RE: **Palen Solar Power Project, Docket No. 09-AFC-7**

Responses to CEC Information Requests
Reconfigured Alternatives 2 and 3
Biological Resources
09-AFC-7

PALEN SOLAR POWER PROJECT (09-AFC-7) CEC STAFF DATA REQUESTS DATED JULY 9, 2010
Technical Area: Biological Resources (AFC Section 5.3) Response Date: July 19, 2010

PALEN SOLAR I, LLC		Mapping by Miles D. Kenney, PhD, PG	
AEOLIAN SAND MIGRATION ZONES, AND WIND VECTOR MAP FOR RECONFIGURED ALTERNATIVE 2		M. Kenney	7/20/2010
		Plate 1

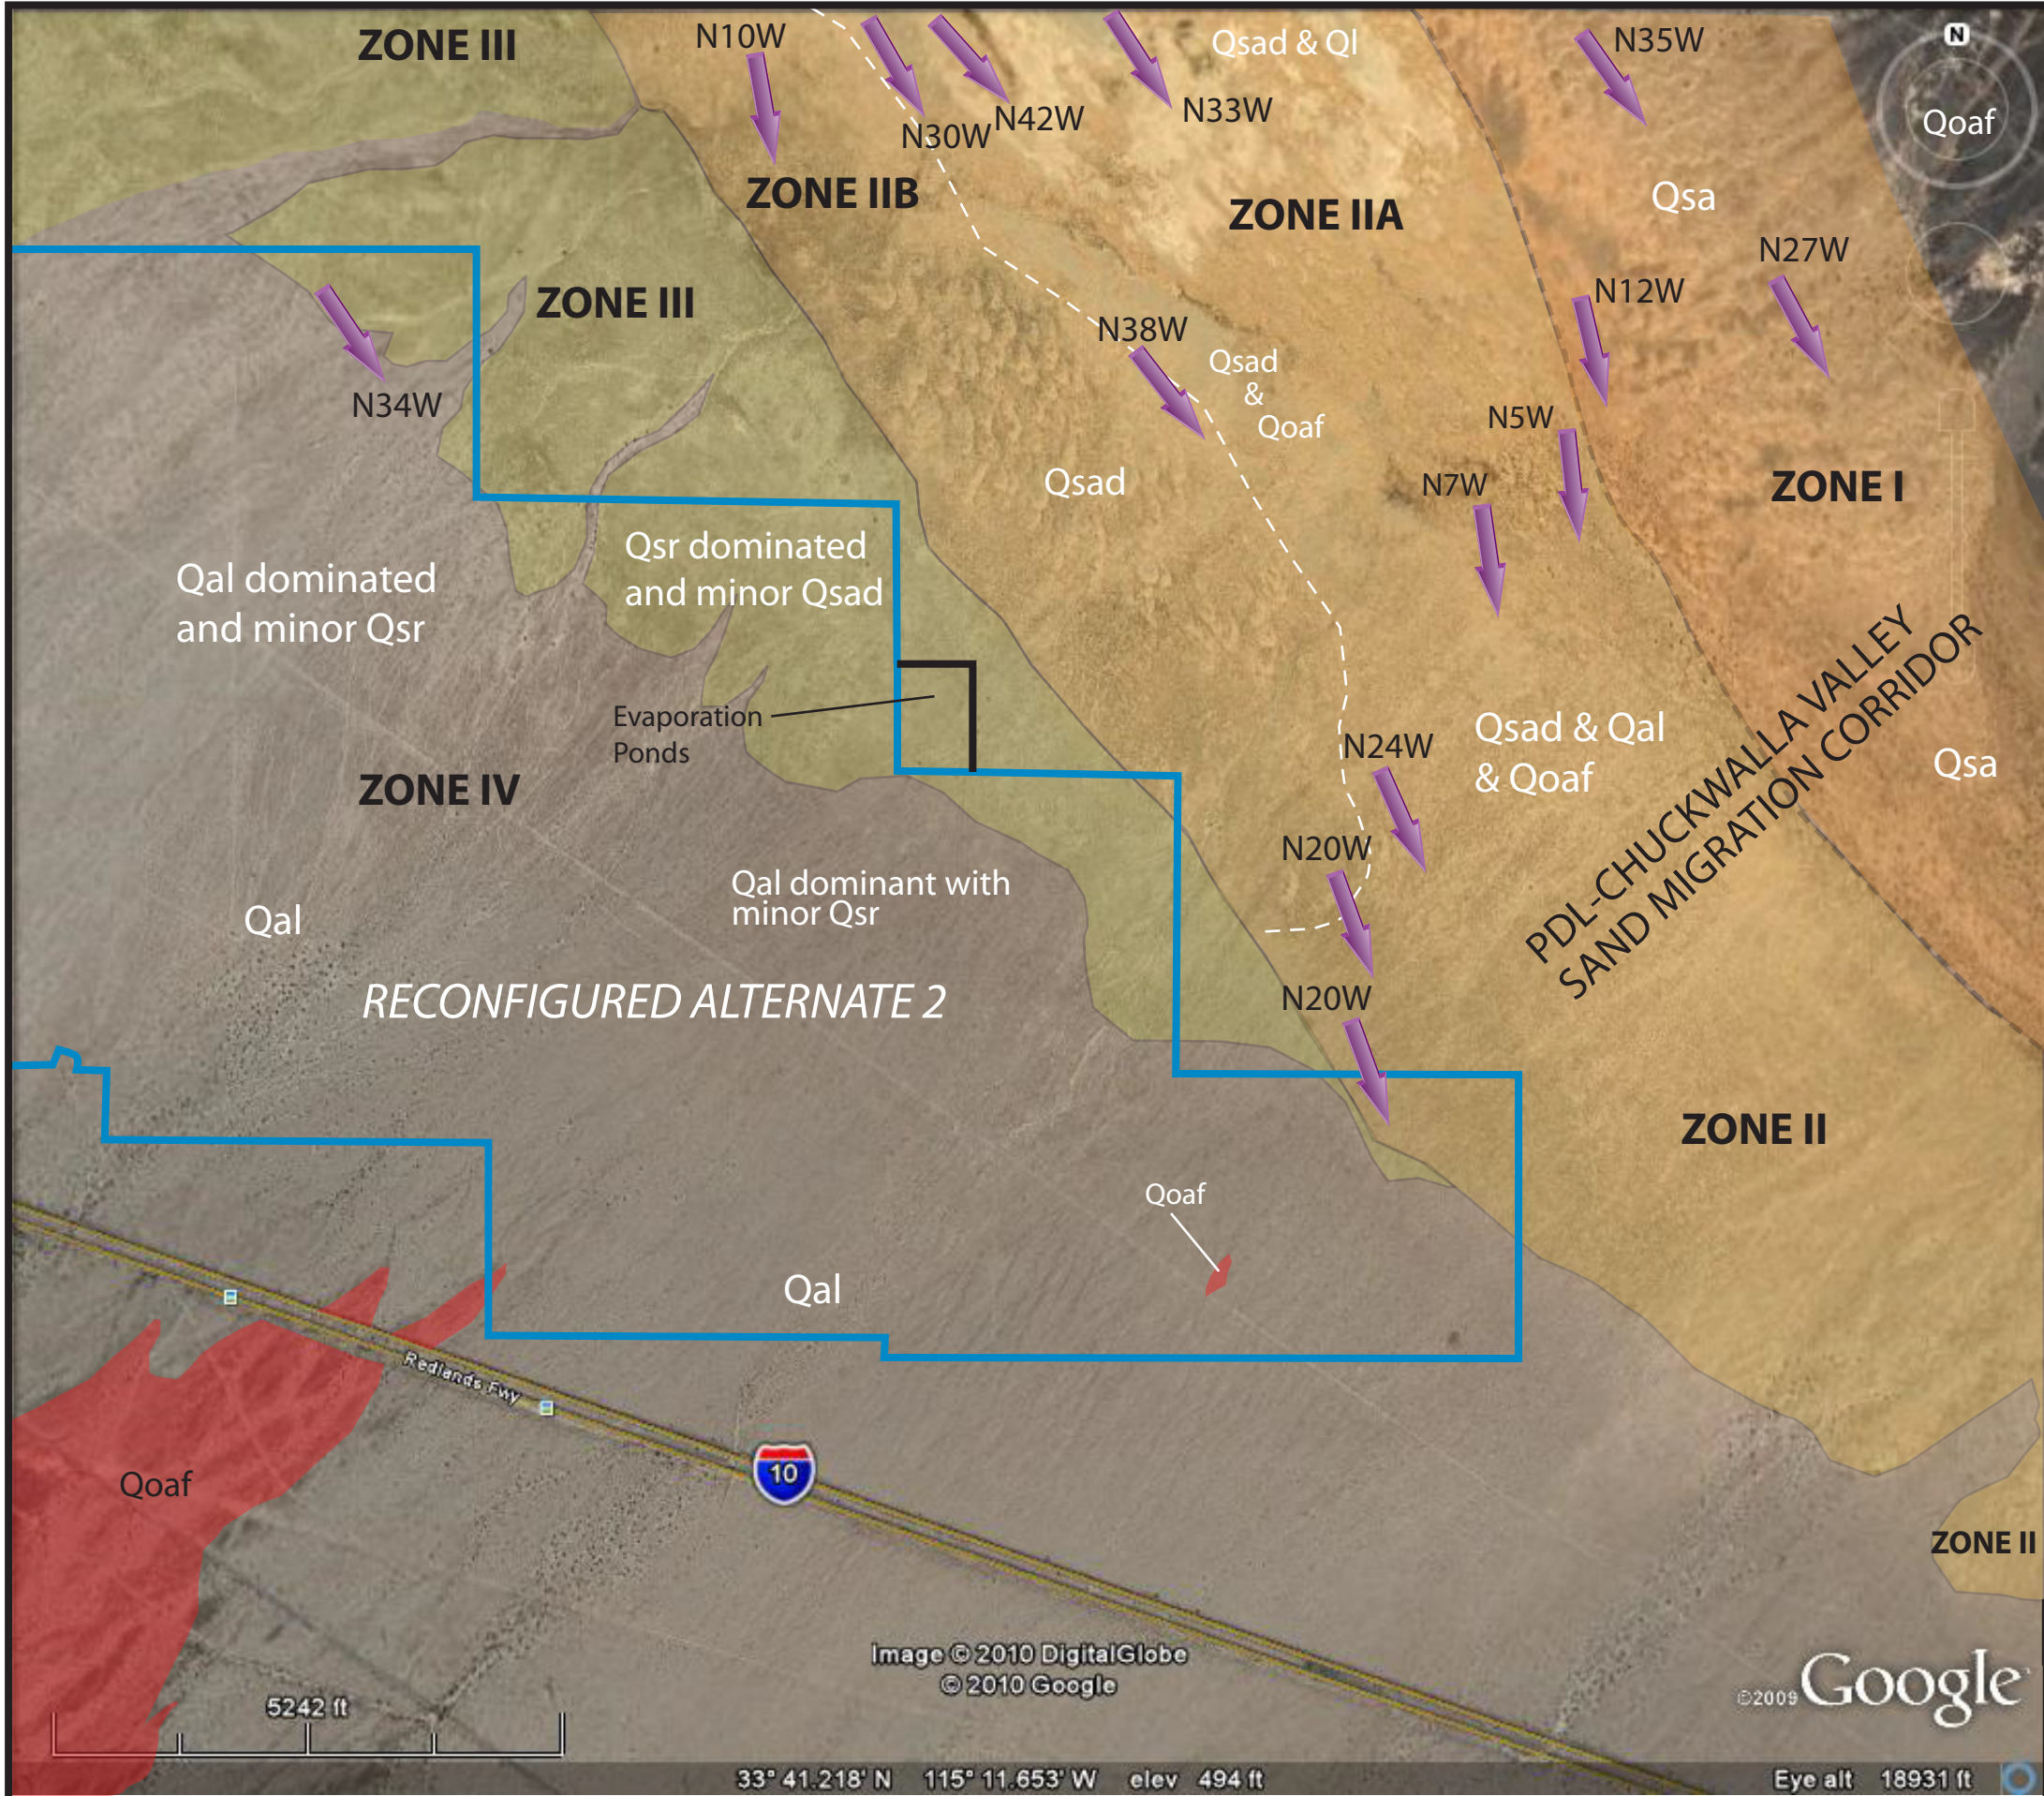
"An analysis of impacts to the sand transport corridor and Mojave fringe-toad lizard habitat, including direct and indirect impact acreages (by Zone and also overall MFTL habitat). If sand management activities such as clearing accumulated sand from the base of the wind fencing are proposed (please provide as much detail as possible on those proposed activities, including information about the anticipated frequency and volume of sand removal, the kind of equipment that would be used to excavate and transport the sand, measures that would be taken to protect surrounding habitat and wildlife, and a figure depicting the location proposed for depositing sand."

The focus of this letter report is to provide findings in the form of Plates (maps) regarding wind shadow areas within aeolian (wind) sand migration corridors for two alternative configurations for the PSPP. Specifically, to evaluate the aerial extent of the wind shadow regions defined as areas downwind from the prevailing winds within designated aeolian sand migration corridors. The two alternative

The wind shadow regions are shaded as light purple and dark purple to represent areas where blocked aeolian migrating sand is either minor within Zone III to moderate within Zone II (and IIB) respectively.
